Document control						aurecon	
<b>Report title</b>		Hydrologic Model Calibration and Verification Review Report					
<b>Document ID</b>		238021-0000-REP-KT-0002	<b>Project number</b>		238021		
<b>File path</b>		238021-0000-REP-KT-0002_Hydrologic Model Calibration and Verification Review.docx					
<b>Client</b>		Prepared for the State of Development (acting through): Department of State Development, Infrastructure and Planning/Department of Natural Resources and Mines				<b>Client contact</b>	Pushpa Onta
<b>Rev</b>	<b>Date</b>	<b>Revision details/status</b>	<b>Prepared by</b>	<b>Author</b>	<b>Verifier</b>	<b>Approver</b>	
A	18 November 2013	Issued for Internal Review	C Smyth	R Ayre T Campbell	D Carroll	C Russell	
B	20 December 2013	Issued for Client Review	C Smyth	R Ayre T Campbell	D Carroll	C Russell	
0	08 April 2014	Final Issue	C Smyth	R Ayre T Campbell	D Carroll	C Russell	
1	09 July 2014	Final Issue	C Smyth	R Ayre T Campbell	D Carroll	C Berry

# Brisbane River Catchment Flood Study – Hydrology Phase

Figure 2-1 Brisbane River Basin DNRM sub-catchments (Source: Brisbane River and Pine River Flood Study (DNR, 1993))

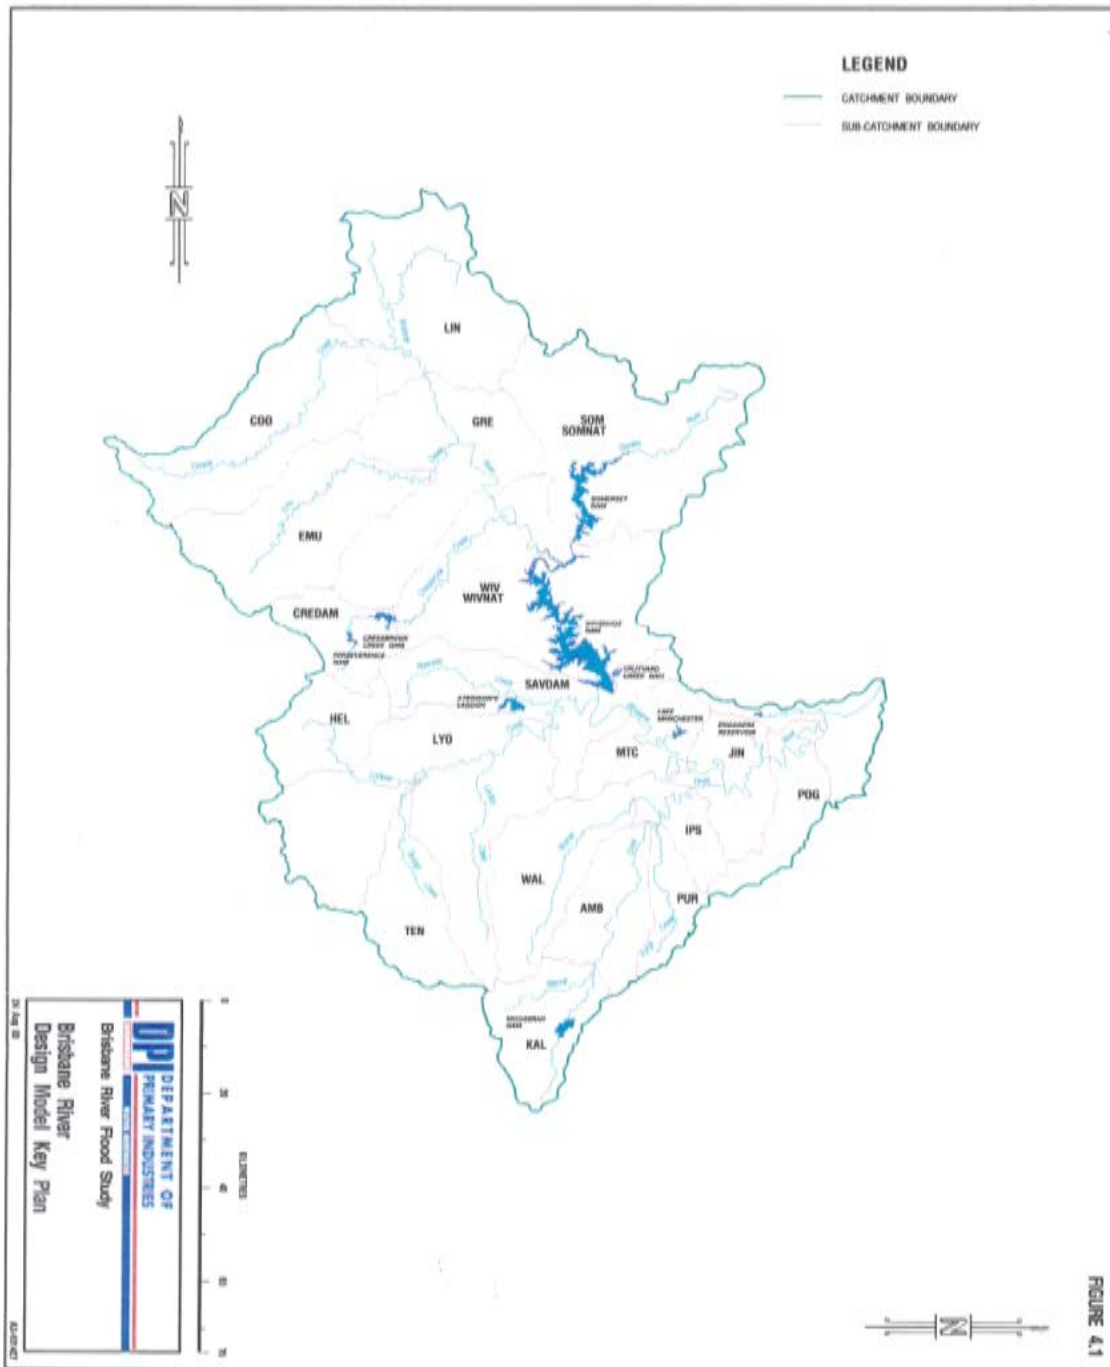
Seqwater divided the Brisbane River basin into seven sub-catchments (refer to Figure 2-1), representing the main contributing tributaries and the mainstream of the Brisbane River. When considering the sub-division adopted for this investigation, the following factors were considered:

Seqwater recognised that decreased scale (increased number of models) could provide an opportunity for applying locally specific loss and routing parameters. For comparison, the 1994 study conducted by DNRM subdivided the Brisbane Basin into 20 sub-catchments, including six sub-catchments above Wivenhoe Dam as shown in Figure 2-1.

Aurecon agree with this conclusion and concur that the URBS model representation is appropriate for use in the BRCFS Hydrology assessment in all but one location. It was found that the DEM used by Seqwater included the Kedron Brook catchment as part of the Lower Brisbane River sub-catchment. This is not the case (as represented in more detailed topographic information) therefore subareas associated with Kedron Brook catchment have been removed from the Lower Brisbane model. No further refinement to the sub-catchment configuration is suggested for the use of the hydrologic model in the BRCFS – Hydrology phase.

Figure 2-2 Brisbane River Basin Seqwater sub-catchments (Source: Brisbane River Flood Hydrology Models (Seqwater, 2013))

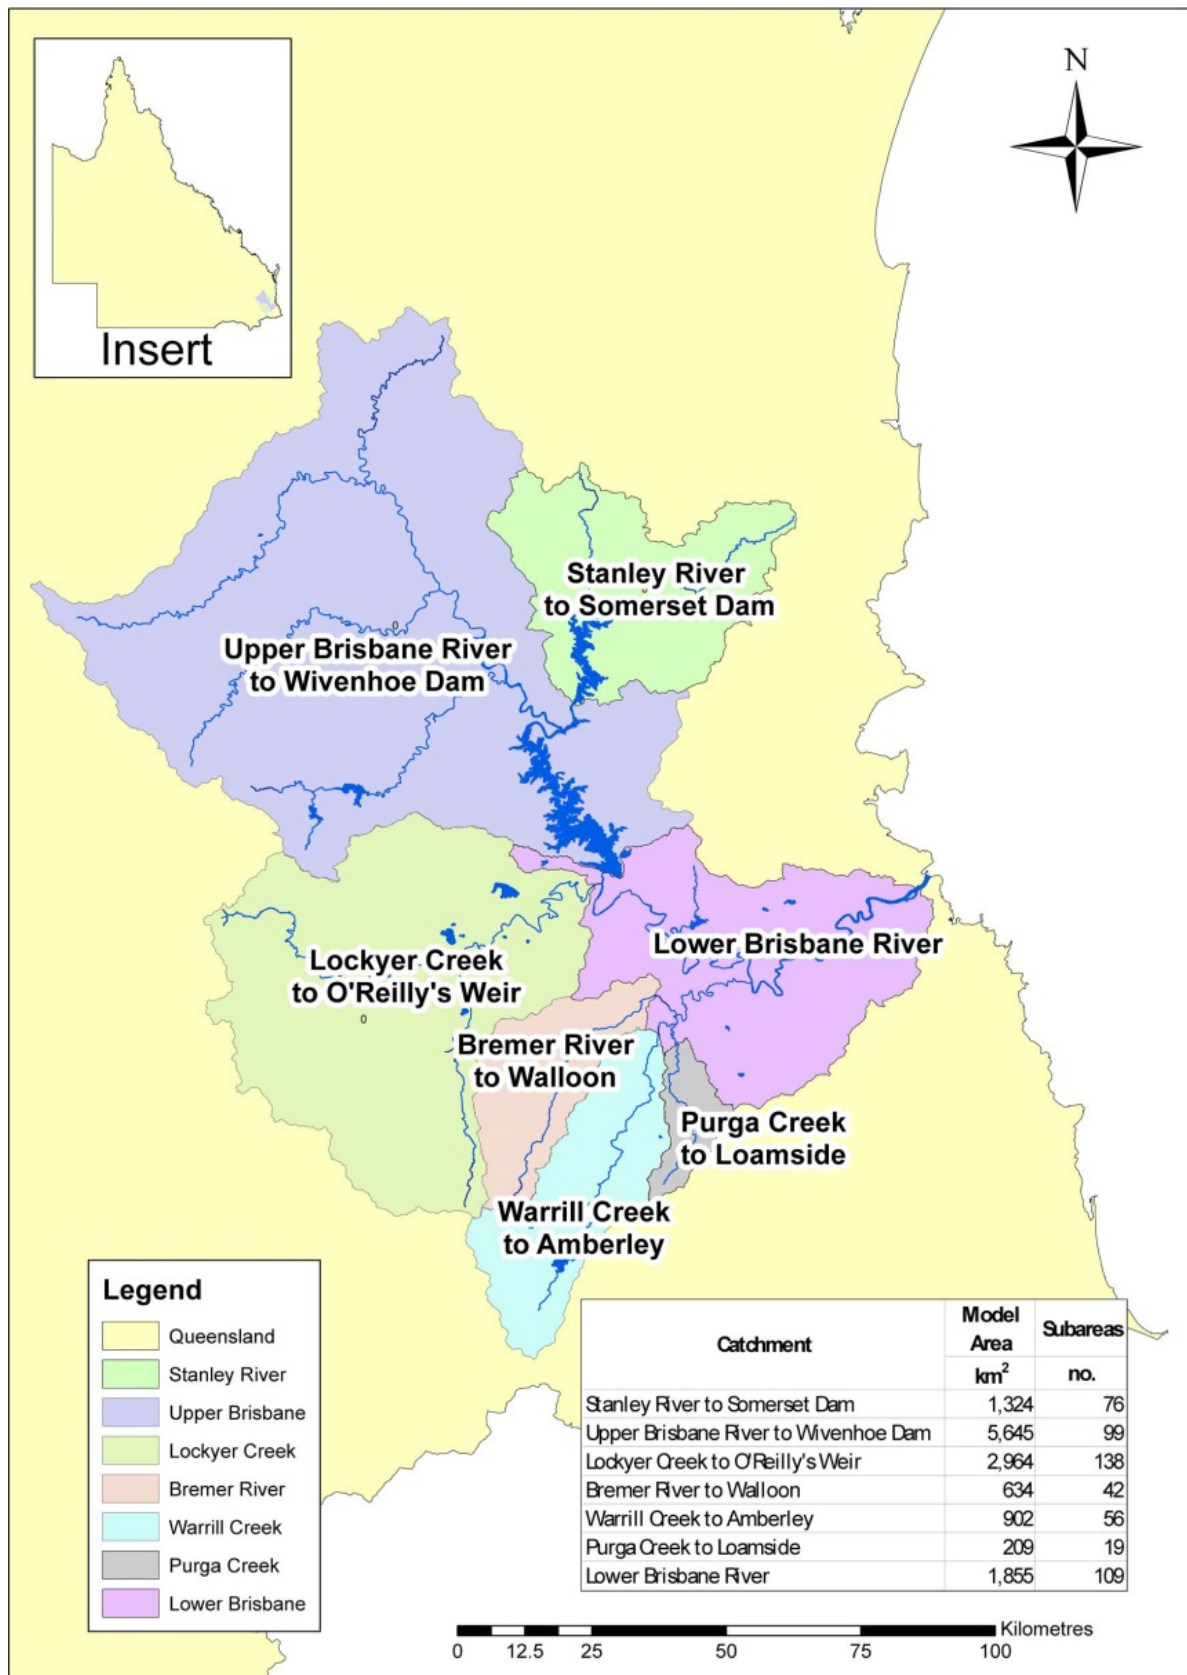
Seqwater argued that the increased division and number of models adds greater complexity (hence potential for errors) and also decreases the potential to make best use of available gauge data with consideration of rating uncertainties. The final adopted basin sub-division was considered an optimal compromise between the factors above. The resultant sub-models are shown in Figure 2-2.

The Seqwater Peer Review Panel endorsed the catchment sub-division as they considered it allowed *'for separate parameterisation and calibration of the tributary models, and different vector files for pre- and post-dam conditions reflect the specific characteristics of each catchment area. Overall, the adopted URBS model representation of the Brisbane River catchment is considered to strike the right balance between model complexity and modelling efficiency.'*
